CITY OF MADISON
CITY ENGINEERING DIVISION
DEPARTMENT OF PUBLIC WORKS
PLAN OF PROPOSED IMPROVEMENT
PHEASANT BRANCH GREENWAY ENHANCEMENT

CITY PROJECT NO. 14370

ADDENDUM #2
REVISED THE FOLLOWING:
SHEETS D1-D3
SHEETS EC1-EC4
SHEETS G13, G15, G112
SHEETS P1-P19, P21, P24-27
SHEETS U1-U18, U22
SHEETS E1-E6
SHEET PM1
SHEETS X32A-X34, X45-X48

REVISION 2
SHEET EC1-EC2
SHEETS P9, P13, P14
SHEETS U1, U5, U9, U11, U16, U19, U21
SHEETS X18-X19, X48

P1

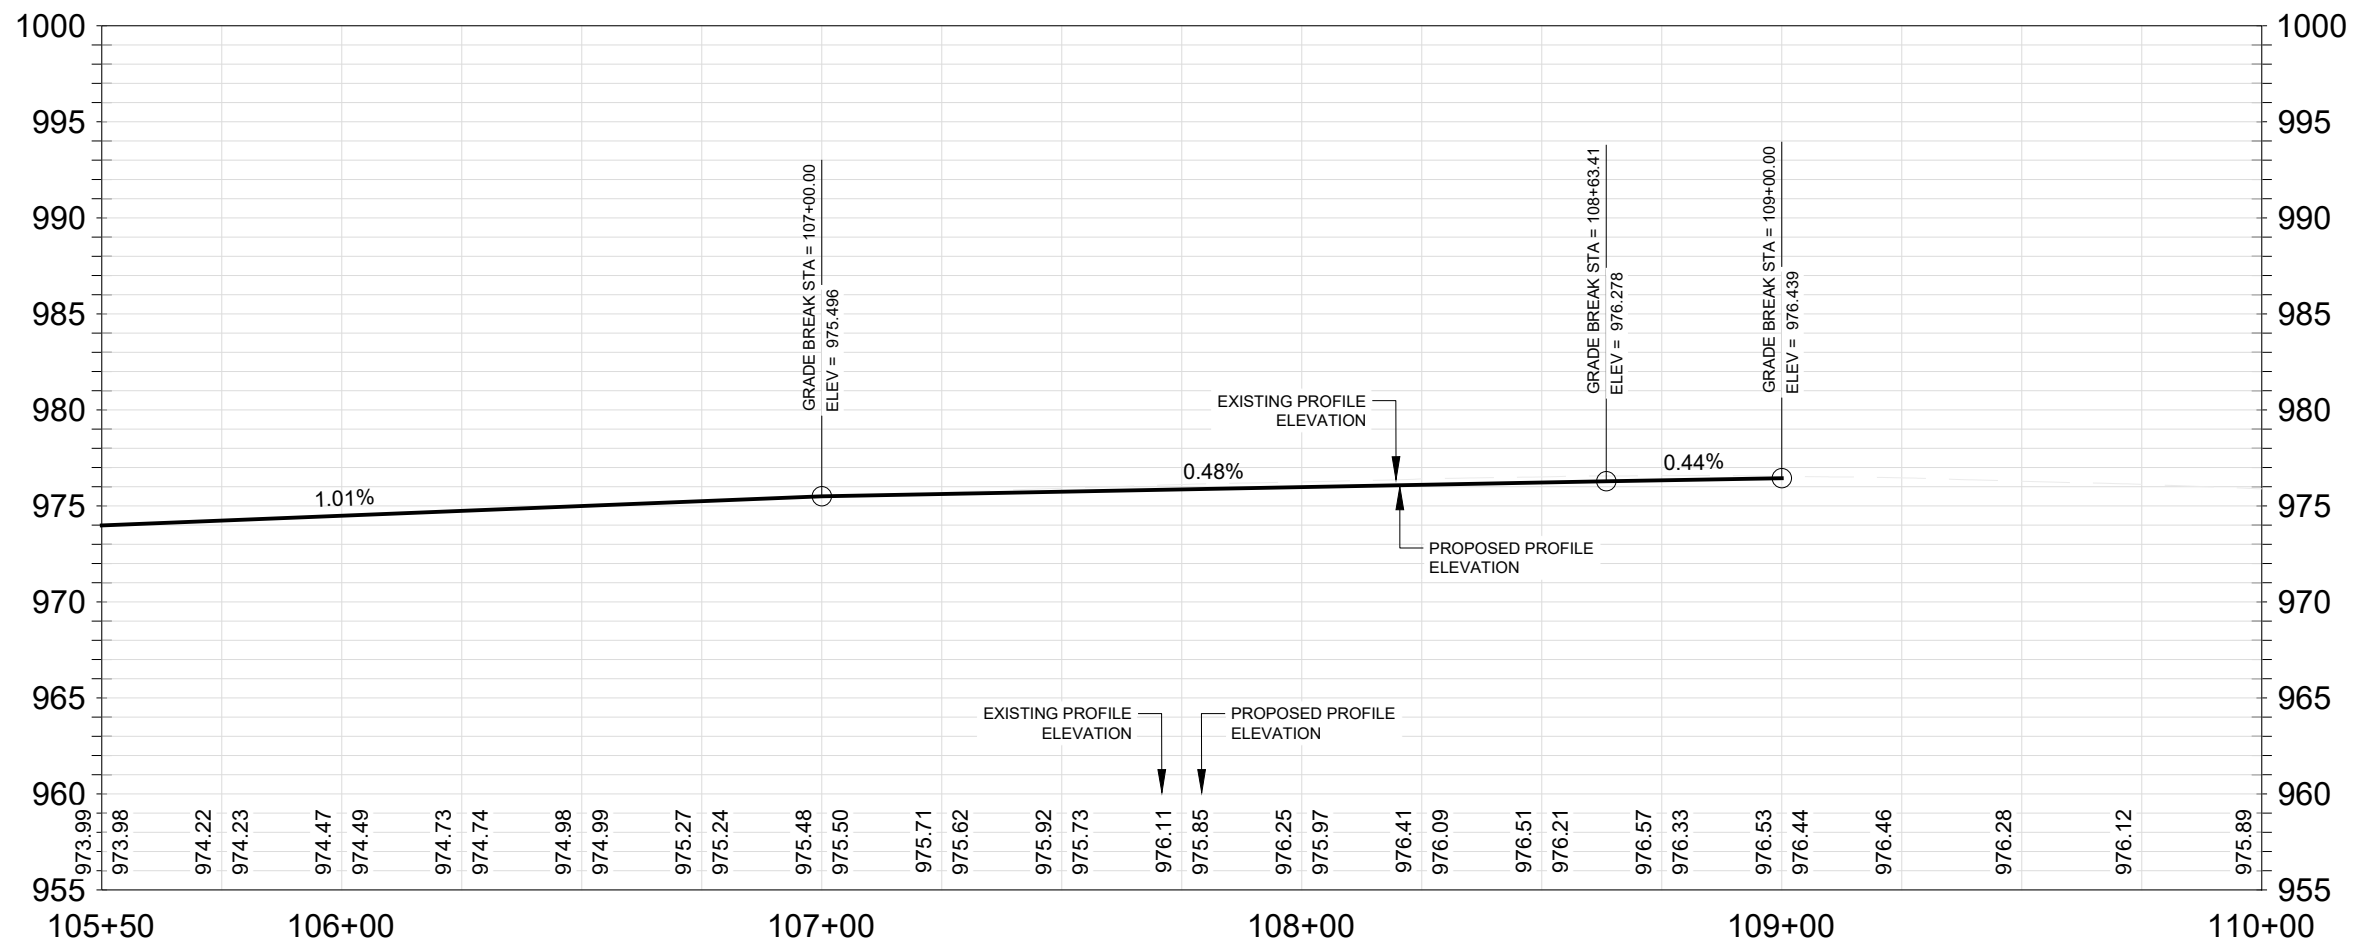
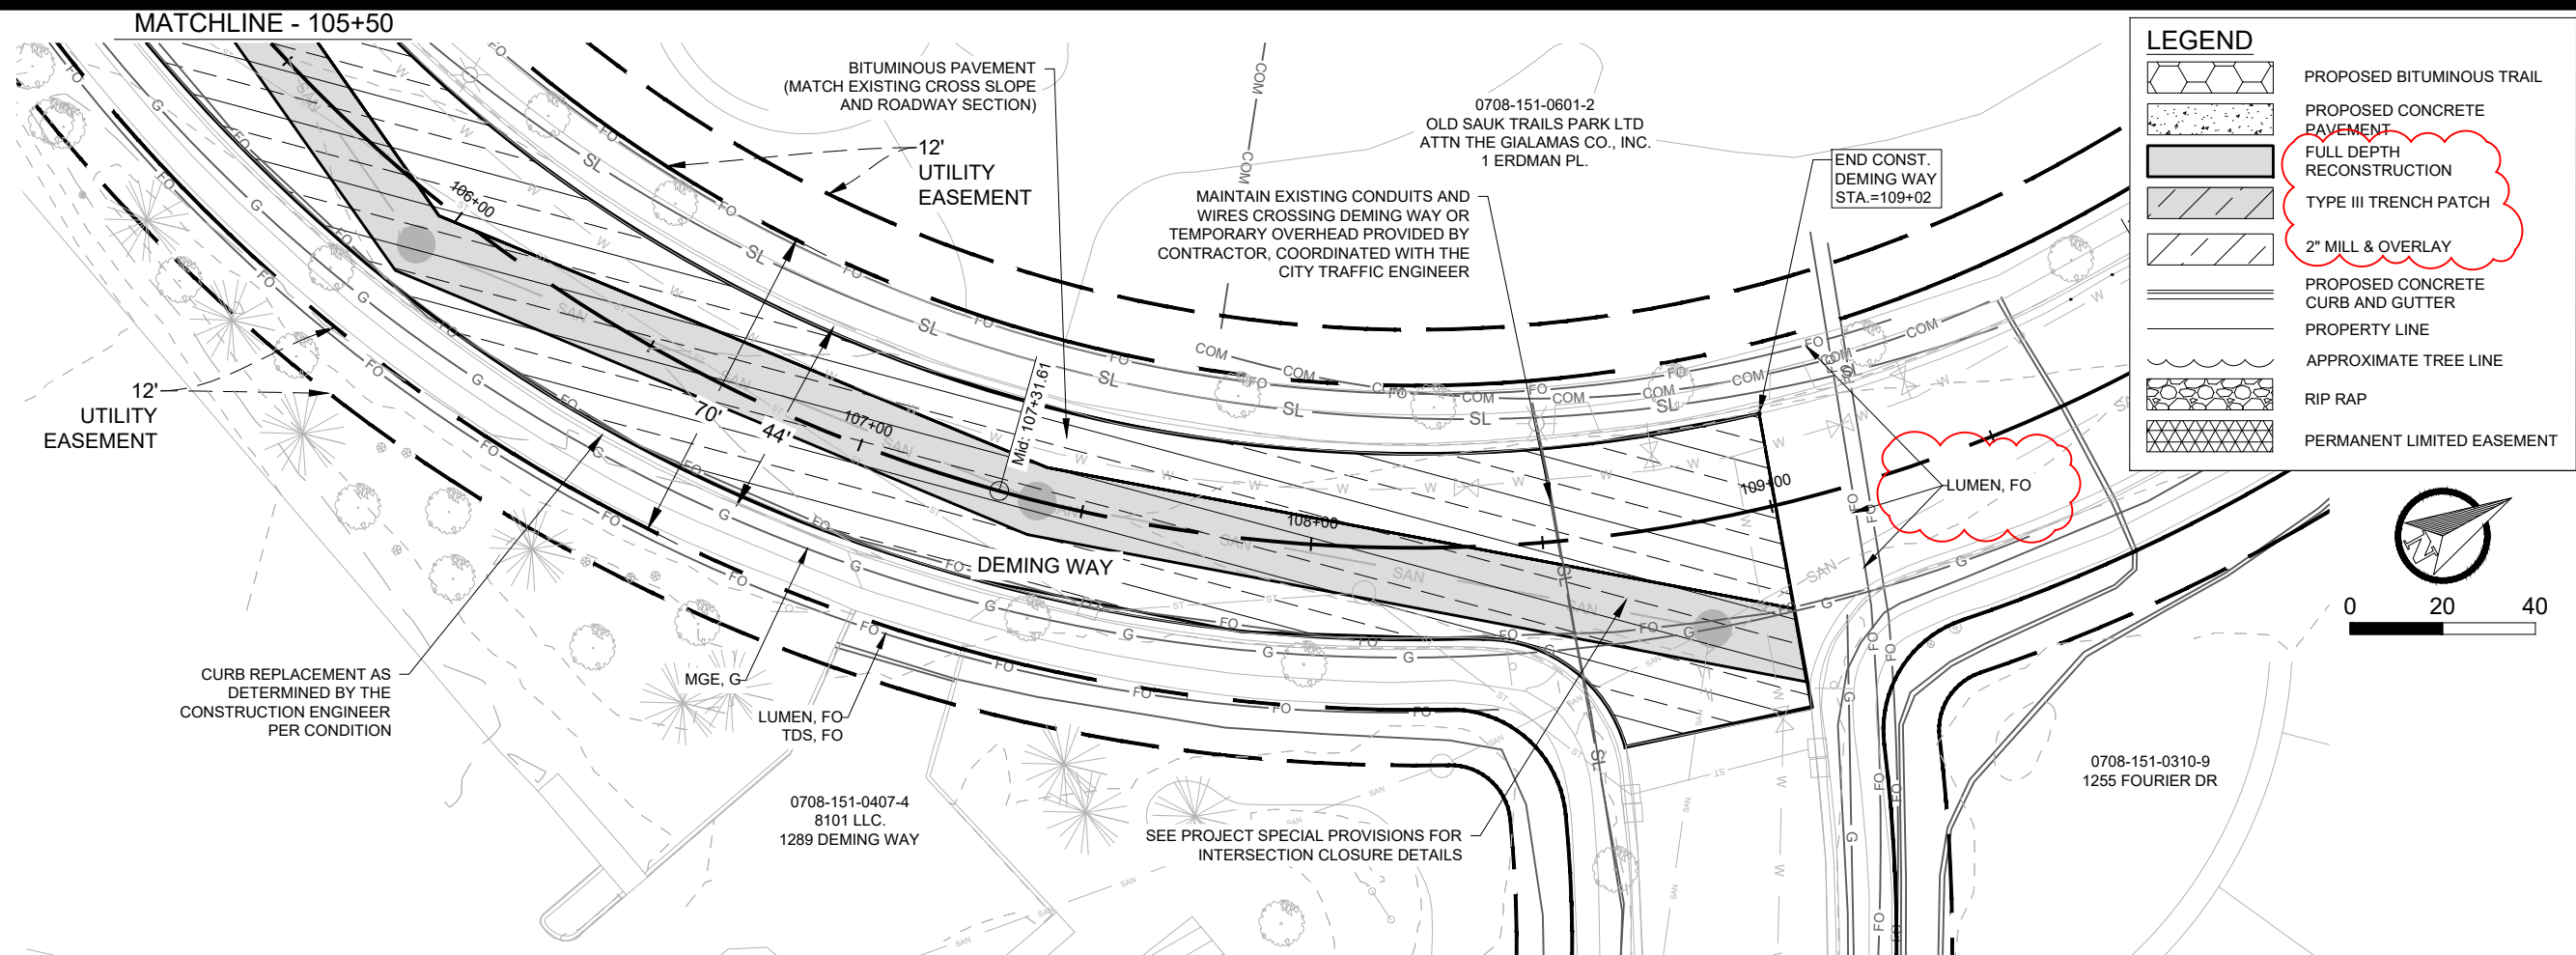
ADDENDUM NOTE:
-UPDATED LEGEND
-ADDED PRIVATE
UTILITY NOTES
